SUBJECT: REQUEST FOR ADDITIONAL INFORMATION LETTER NO. 09
(SRP SECTIONS: 02.05.01 – BASIC GEOLOGIC AND SEISMIC
INFORMATION, 02.05.03–SURFACE FAULTING) RELATED TO THE
VICTORIA COUNTY STATION EARLY SITE PERMIT APPLICATION

Request for Additional Information No. 5678 Revision 0

Victoria County Station ESP
Exelon Texas
Docket No. 52-042
SRP Section: 02.05.01 - Basic Geologic and Seismic Information
Application Section: 2.5.1

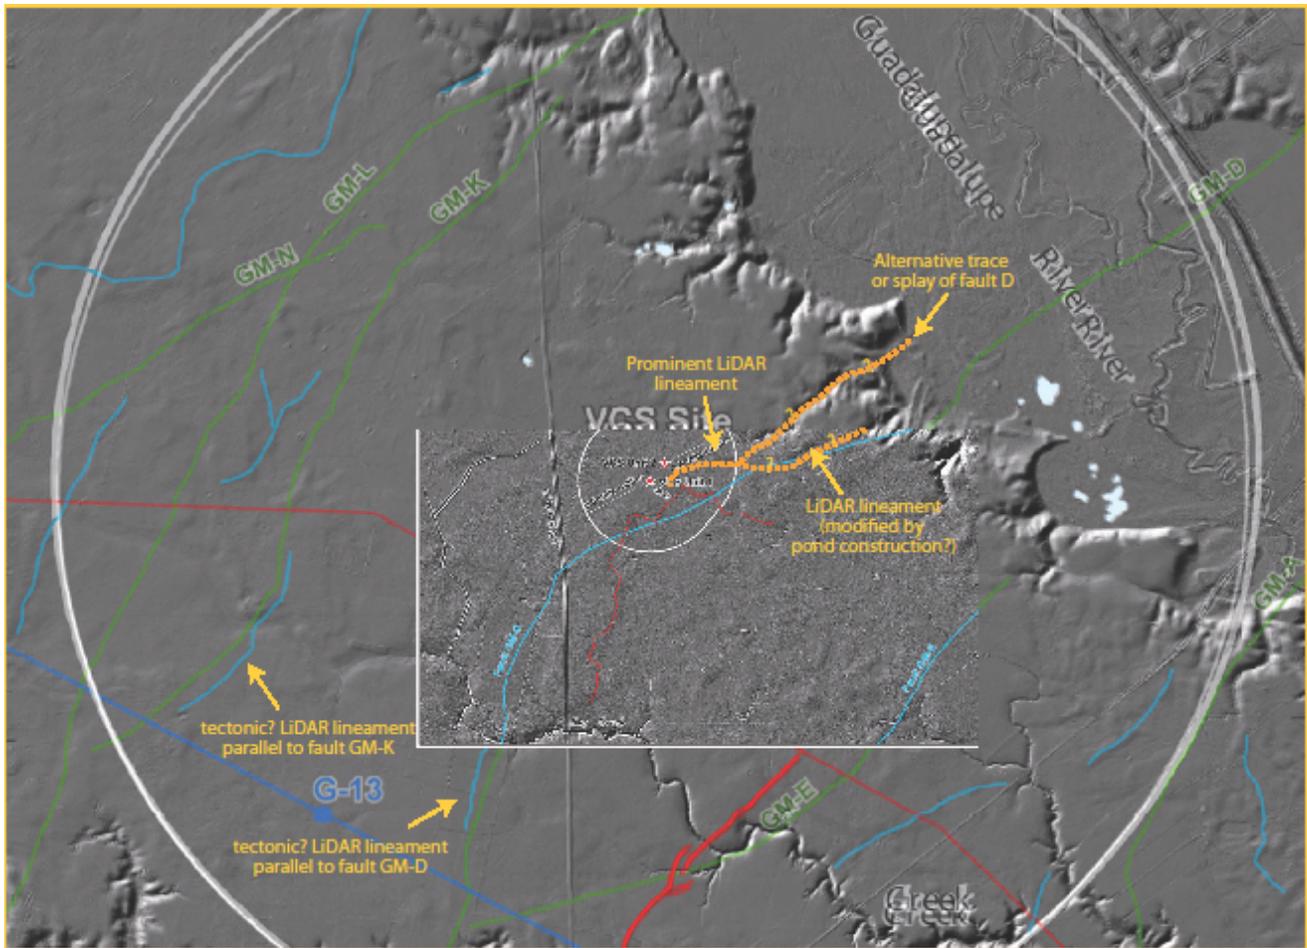
SSAR Section 2.5.1.2.4.2.2 describes criteria used to classify lineaments from airphoto and LiDAR data as related either to growth faulting or to non-tectonic processes. Many lineaments interpreted by you to be of fluvial origin (Figs. 2.5.1-37, 41, 42) lie near and on-trend with surface projections of faults K and D (**see attached Figure 1**). One lineament parallels fault K turn-for-turn for more than 3 km, yet is interpreted as fluvial in origin. Many lineaments interpreted as fluvial scarps trend nearly perpendicular to the regional slope and flow direction, and appear to be southeast-facing, consistent with the slip direction of growth faulting in the region. In support of 10 CFR 100.23 please discuss the alternative interpretation that many of these lineaments are surface manifestations of active growth faulting rather than fluvial processes, and the implications for site safety.

In SSAR Section 2.5.1.2.4.2.3 you describe the identification of growth faults from aerial photographs and LiDAR topography shaded-relief maps. The staff observes that both air-photo and LiDAR data (Fig. 2.5.1-37, -38, -42) suggest that growth fault D (or a splay thereof) may extend 1-2 km northeastward instead of turning sharply to the southeast near the power block (**see attached Figure 1**). This may be a more linear trace for Growth fault D that would correspond to the more typical trend of other GeoMap faults in the vicinity. In addition, cross-sections in Figure 2.5.4-15, between boreholes B-04 and B-2316 and Figure 2.5.4-16, between boreholes B-2354 and B-2322, show small (~1 m) steps in topography and 1-3 m apparent offsets of several subsurface units that may be evidence of a fault trending in this direction.

USGS RAI 2.5.1-Figure 1. Composite of parts of figures 2.5.1-38, 40, and 42, showing alternative traces or splays of fault D (orange dashed lines). Also highlighted are two LiDAR lineaments interpreted as fluvial features by the Applicant that closely parallel the projected traces of faults GM-K and GM-D, suggesting a tectonic origin.

In accordance with 10 CFR 100.23 (d), explain why this potential trend was not considered part of fault D. Please provide an evaluation of the borehole data, cited above, with regard to a possible shallow fault trending northeast rather than southeast. Please discuss the safety implications of this possible fault splay, which would be closer to the power block.
